ARKANSAS POWER & LIGHT COMPANY

SUBJECT: Arkansas Nuclear One - Unit 1
Docket No. 50-313
License No. DPR-51
Reactor Vessel Overpressurization
(File: 1510)

ADDITIONAL INFORMATION
CONCERNING
OVERPRESSURE PROTECTION
FOR
ARKANSAS NUCLEAR ONE, UNIT NO. 1
DOCKET NO. 50-313

Figure 3.1.2-3

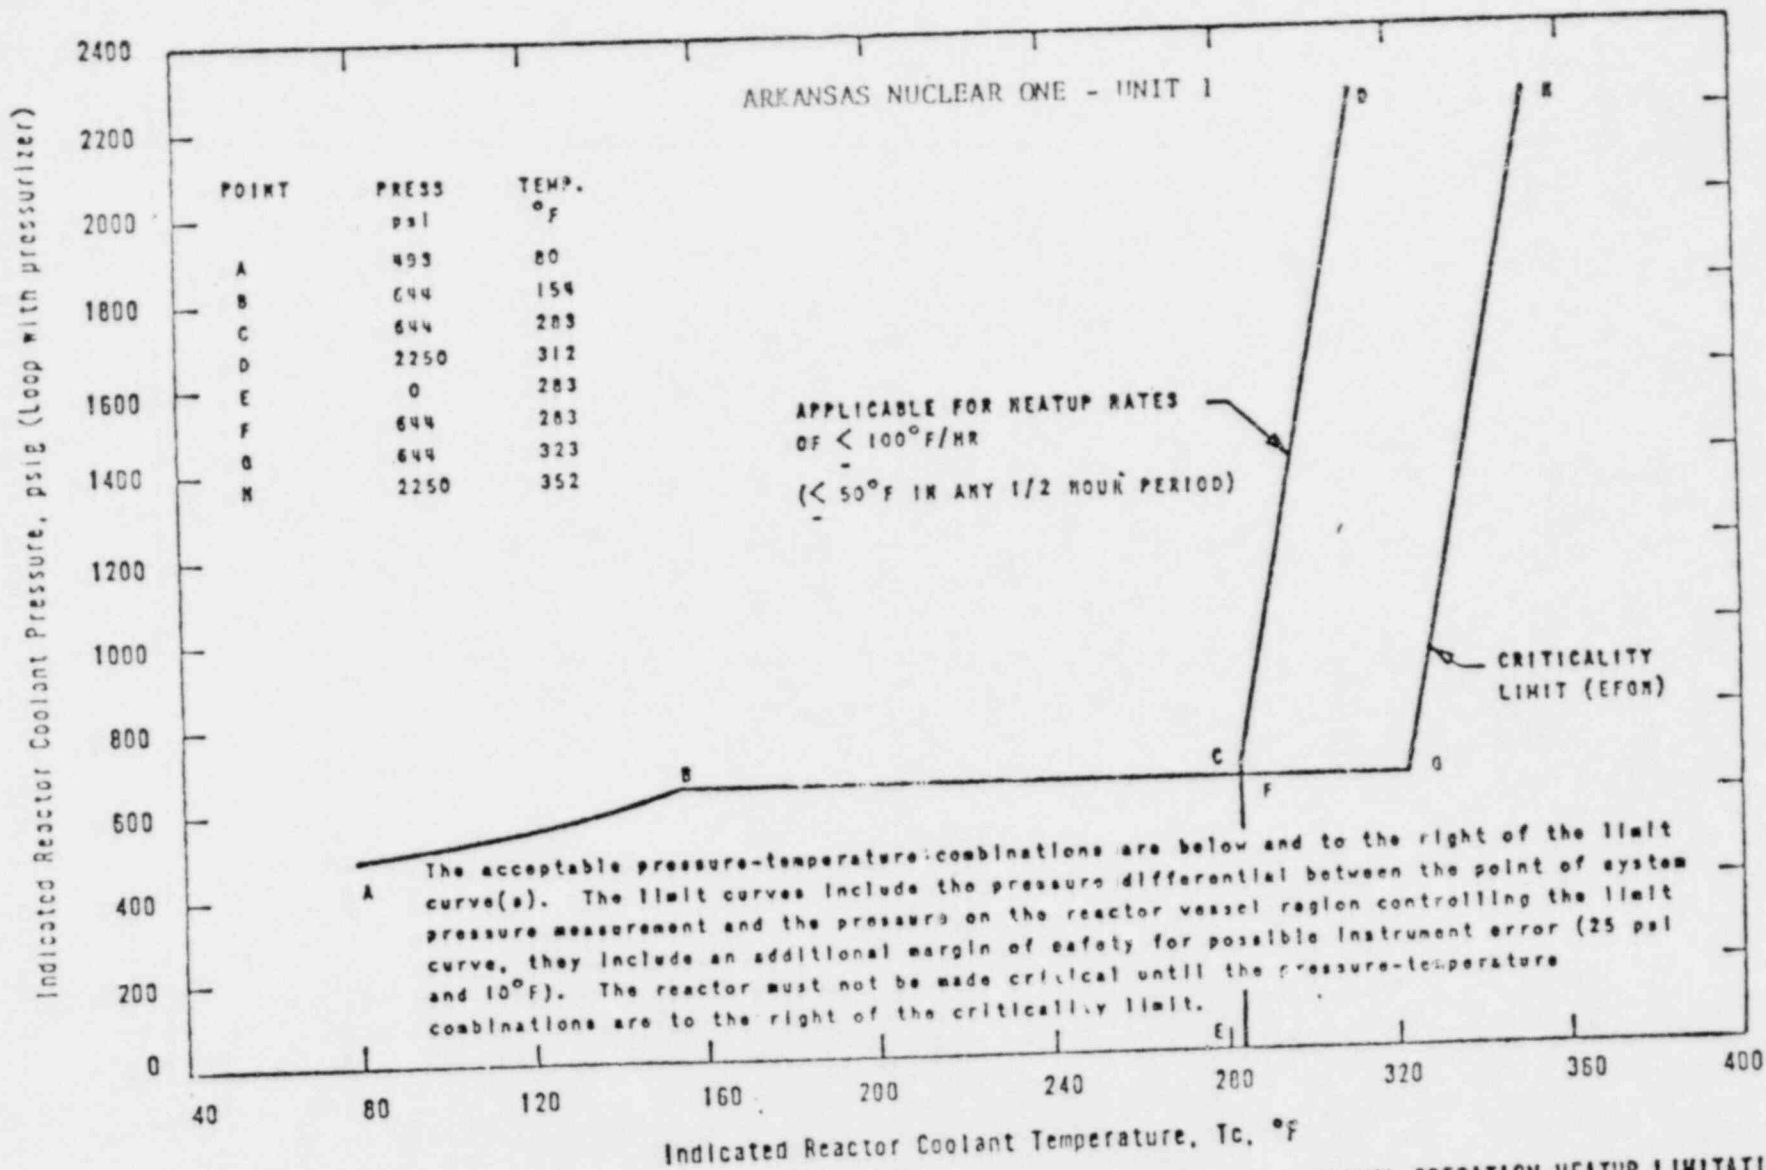
- a. Provide a copy of the current ANO-1 Appendix G curve.
- b. Does the 550 psig setpoint provide adequate assurance that the Appendix G curve limits will not be exceeded for all temperatures below the minimum pressurization temperature?

- a. A copy of the current ANO-1 Appendix G heatup and cooldown curves is attached. These are what the present 550 psig setpoint is based upon.
- b. From the attached curves it is shown that at any temperature above 120°F the maximum pressure allowed is above 550 psig. It is not credible for the reactor vessel to go below 120°F due to decay heat load input to the primary fluid.

Figure 3.1.2-2

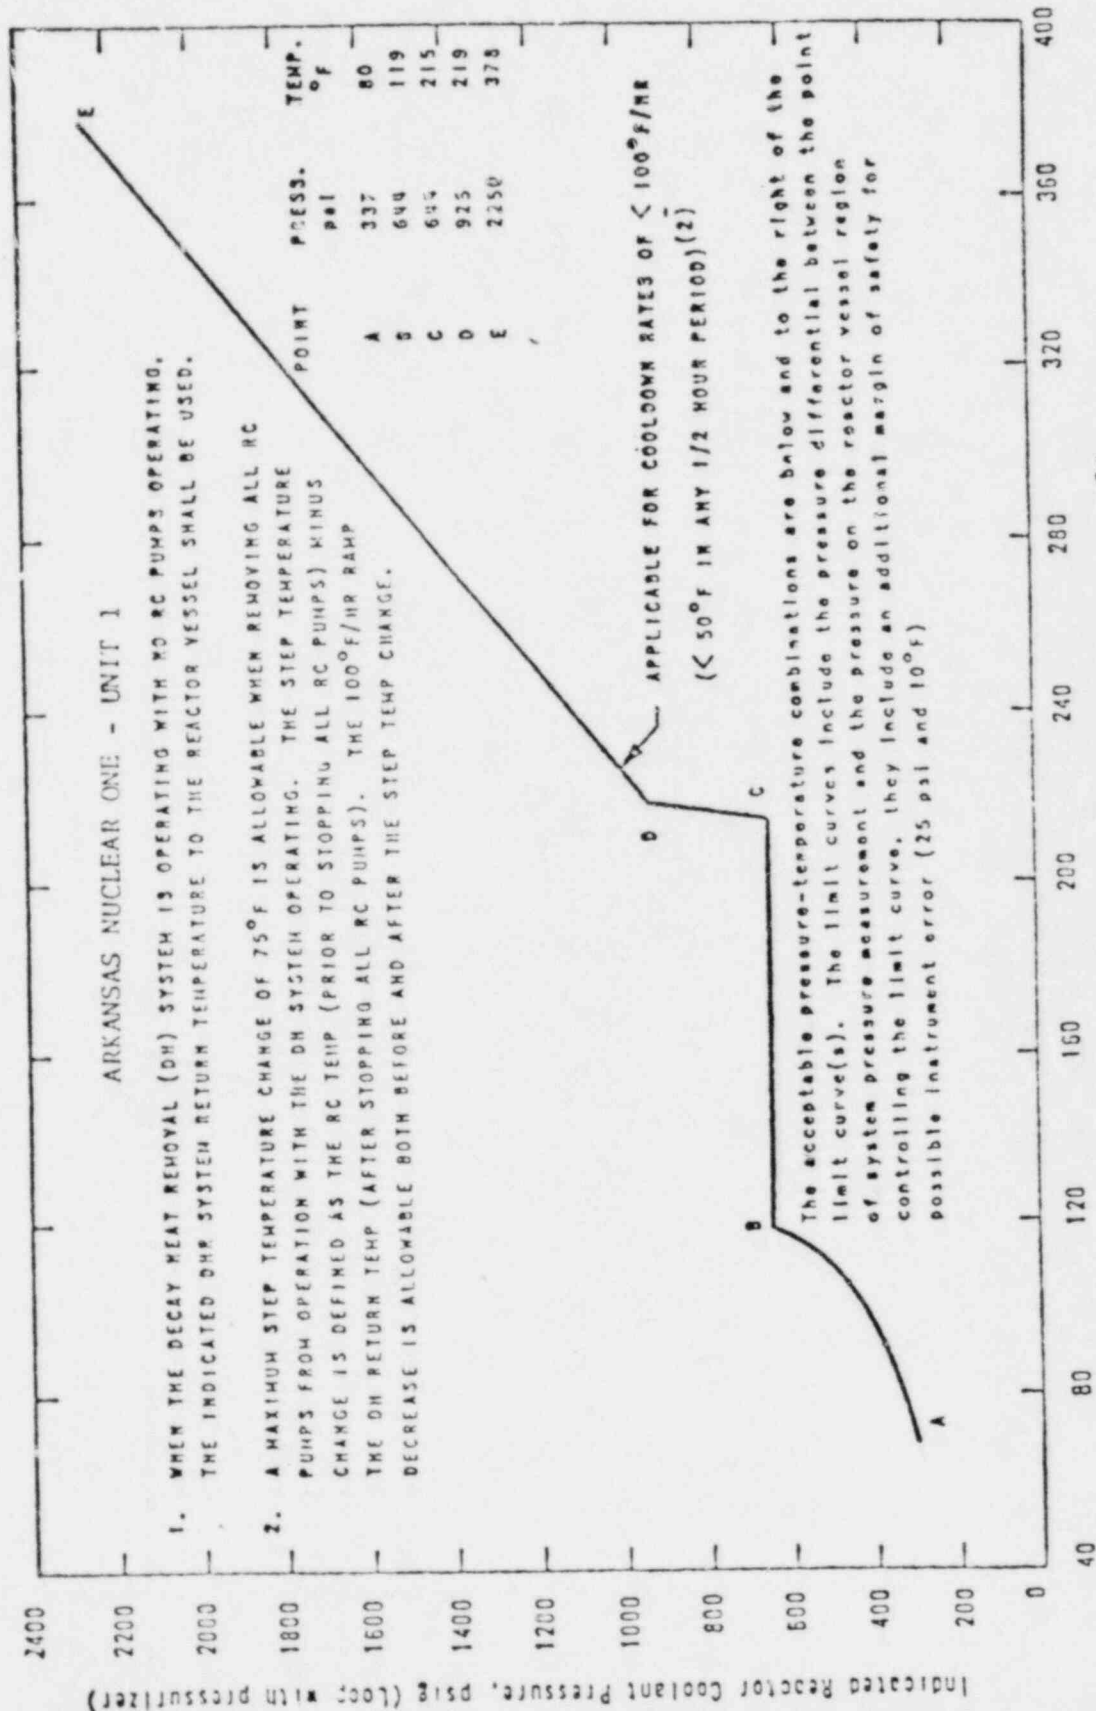
The Branch Technical Position requires the Arkansas Nuclear One, Unit 1 (ANO-1) overpressure protection system (OPS) to prevent exceeding the applicable Technical Specifications and 10CFR50 Appendix G limits. In your analysis and system description, you use 550 psig as the low temperature PORV setpoint and as the value that RCS pressure is allowed to reach prior to any credited operator action.

The current Appendix G limits are for the first 5 EFPY. Therefore, they cover up to the sixth (6) EFPY.
